From: Griffin, Tim
Sent: 25 March 2024 11:00
To: Morris, Rachael
Cc: Dyer, Tim; Ellison, Mark; Stringer, Chris; Malter, Lisa
Subject: O/23/96467 Land adjoining Chalcroft Business Park, Burnetts Lane, West End, SO30 2HH - landscape comments

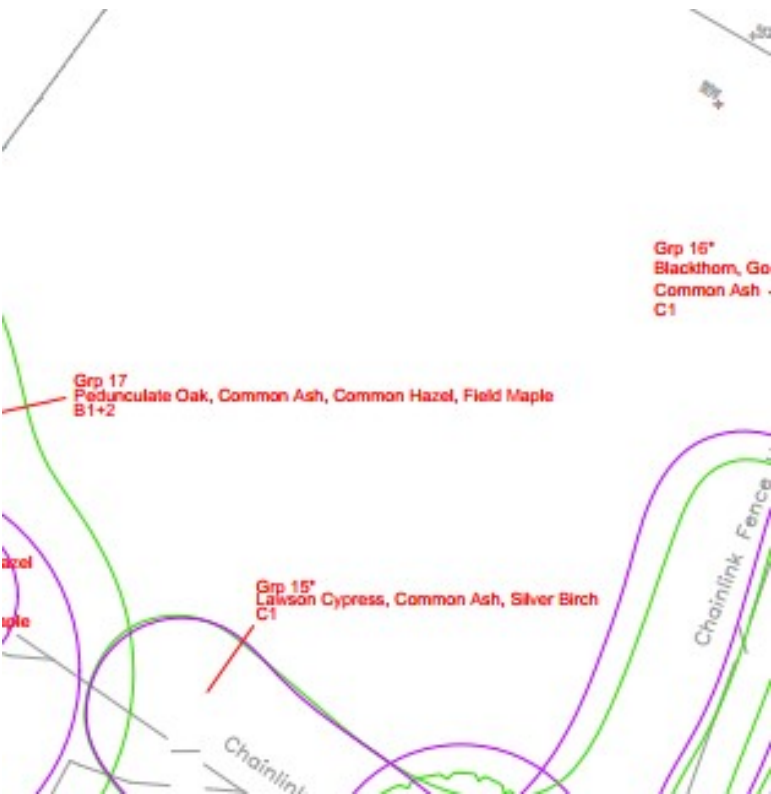
1. Whilst it is good to see that there have been some positive changes to the site layout following Officers previous comments, I remain concerned that the density of proposed development remains too high to allow sufficient space for deliverable Green Infrastructure planting.

The footprint of Building D is overly large extending close to Burnetts Lane. This limits canopy tree planting opportunities that would effectively soften this edge. This tree planting would also filter views from private residences on the opposite side of the road and bolster the streetscene along Burnetts Lane. The snapshot below from the landscape strategy plan highlights the area of concern and the constraints on tree planting. The fact that native tree planting here is indicated mostly by smaller tree symbols, suggest smaller tree species that would have less impact in the wider scene.

We would recommend that Building D is pulled off the boundary, roughly in line with Building C, creating a more generous and continuous landscape buffer along Burnetts Lane.

Below is a very rough mark up to illustrate potential re-design of this area:

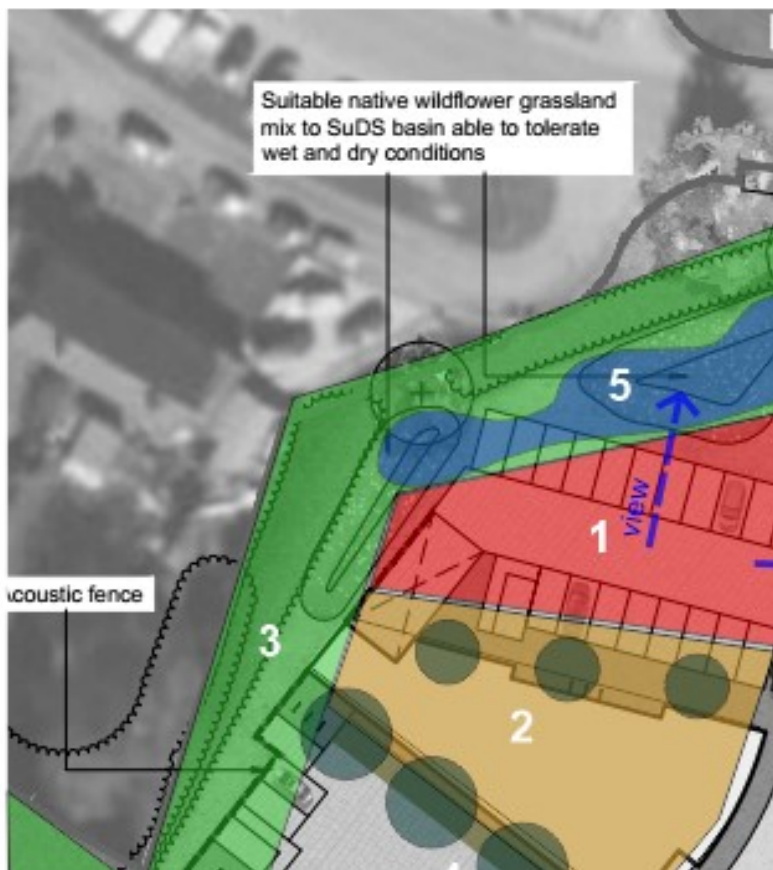
4. The setting for the farm shop is unattractive as it is 'sandwiched' between 2 areas of bland parking. An improved relationship with the proposed SUDs/landscaped area is possible with the building orientated to maximise attractive views. If the parking for the farm shop is relocated to the rear it will not be immediately visible in arrival views.
